**ENT-AN1281**  
**Application Note**  
**VSC8504/VSC8552/VSC8572/VSC8574 Transition Design**  
**Guide**

September 2018

This document highlights considerations for transitioning from revision D to revision E of the VSC8504/VSC8552/VSC8572/VSC8574 devices.

**Figure 1 • VSC8572-02/VSC8574-02 SPI TS/Signal Output**

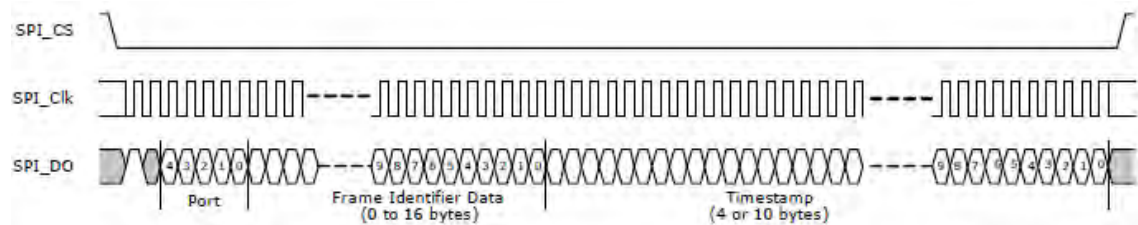
The VSC8572XKS-02, VSC8572XKS-05, VSC8574XKS-02, and VSC8574XKS-05 devices have an errata concerning clock signal generation on the serial timestamp interface, which is also known as the push-out serial peripheral interface (SPI). The serial timestamp output interface may not generate the final 1588\_SPI\_CLK cycle for certain timestamp push-out transactions. This issue can be worked around by programming the SI\_CLK\_LO\_CYCS within the 1588 register configuration to value 0x1. This workaround was first introduced in PHY API version 4.67.04.

As documented in the design considerations of the VSC8574-02 and VSC8572-02 datasheets, the serial timestamp output interface may fail to provide a terminating SPI clock cycle. The failure may appear under two conditions:

- An egress timestamp for a Delay\_Req PTP message (T3) is processed on physical port 1 (and/or port 3 for the VSC8574XKS-02 and VSC8574XKS-05 devices)
- T3 timestamps are concurrently processed on multiple physical ports of a single device

The terminating SPI clock cycle is lost only when the SI\_CLK\_LO\_CYCS value is programmed to 0x2 or greater, which is usually the case because the hardware default is a 50% duty cycle, 31.25 MHz SPI clock (SI\_CLK\_LO\_CYCS and SI\_CLK\_HI\_CYCS default to 0x2). However, a SI\_CLK\_LO\_CYCS value of 0x1 prevents the final SPI clock cycle from being lost, and so can be exploited as one workaround to this bug.

API-4.67.04 forcibly configures the 1588 serial timestamp output interface to have a SI\_CLK\_HI\_CYCS of 0x3 and SI\_CLK\_LO\_CYCS of 0x1. In other words, a 31.25 MHz SPI clock with 24 ns high time and 8 ns low time. Other 1588 devices are unaffected.
